# North Hertfordshire District Council

## Building Conservation comments

**File Ref:** 18/00585/LBC

**Address:** Sandon Bury Farm, Sandon, Hertfordshire SG9 0QY

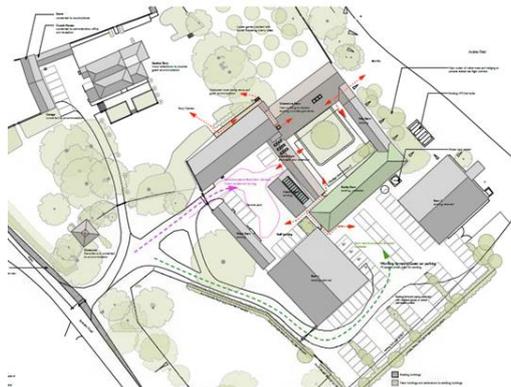
The proposed site layout plan indicates the location of the proposed parking which I consider more respectful of the wider setting to Sandon Bury and the adjacent barn group when compared with that previously proposed under the withdrawn application. Ultimately, however, it is for the case officer to determine the acceptability or otherwise of the car parking arrangement.

Whilst not a conservation matter as such, the proposed layout does, however, raise three questions (which should be considered under the planning application):

1. Due to the fact that the two large Atcost barns remain in agricultural use and with the car park access being the same as the working farm access, it would be presumably be the case that the Atcost buildings will not in use at the time of a wedding. In which case, this must surely limit the operational efficiency of these barns if access is not possible for up to 75 occasions each year and will also result in a rather undesirable first impression for guests arriving at the venue (see photo below). If the barns remain continually in use for what would be up to 75 events per year, then how is access achieved to both buildings considering the parking layout for guests?

2. What provision is there to accommodate parking overspill – how will this be managed if it occurs? and
3. If coaches are bringing guests to the venue, the service yard is identified as the ‘dropping off point’ which is close to the kitchen and with a relatively tight turning facility. I would have thought that if the central parking spaces are removed from the main parking area, would this not provide a sufficient turning area and negate coaches having to enter the service yard? Another

alternative would be to leave the coach drop off where it is and to perhaps consider omitting the 'outside' car parking bays in the 5no. group abutting the rear of the single storey building to the right of the service yard entrance.
